| <b>Subject:</b><br><br><b>HOOD VIBRATION WHILE DRIVING AT HIGHWAY SPEED</b> | <b>Bulletin No:</b> 09-029/12  |
|   | <b>Last Issued:</b> 07/27/2012 |

2013 CX-5 vehicles with VINs lower than JM3KE\*\*\*\*\*120257 (produced before April 18, 2012)

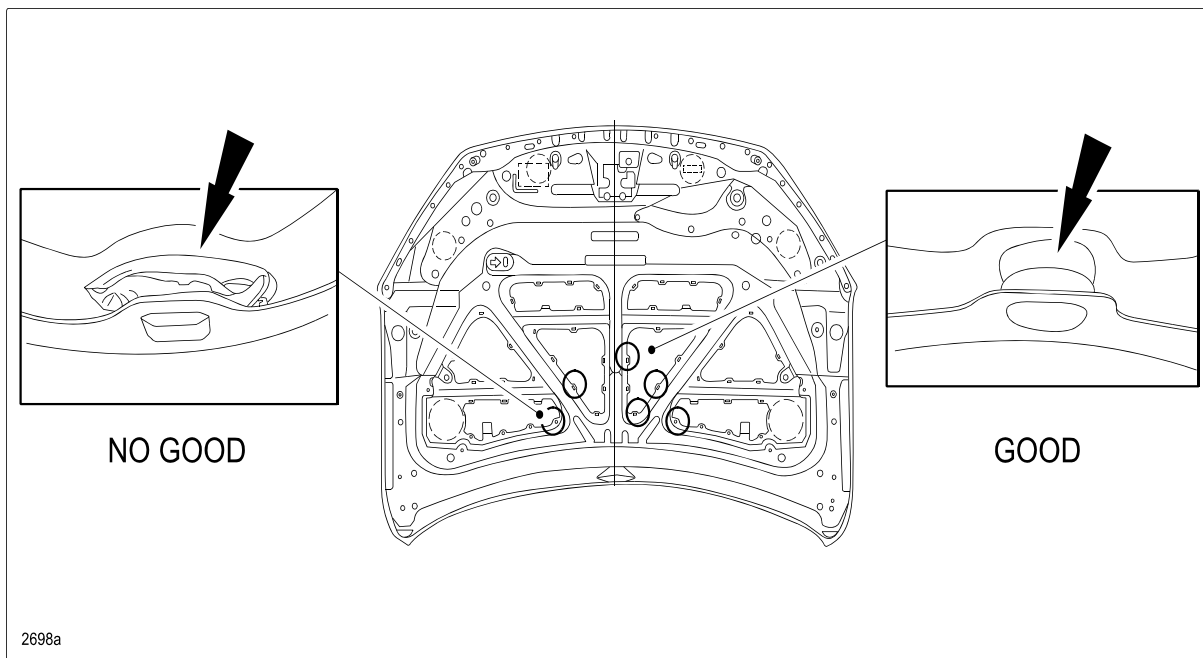
Some vehicles may exhibit a condition where the hood vibrates when driving at speeds of 110 Km/h (68 mph) or more.

The amount of sealant used to fill in the space between the inner frame and outer panel at the bottom area of the hood is insufficient. If the sealant detaches (as shown below on the left), it may cause the hood to vibrate. The amount of sealant has been increased during vehicle production to eliminate the concern.

Additional dampening material will be applied between the hood's inner frame and outer panel and the hood height will be adjusted to apply additional tension.
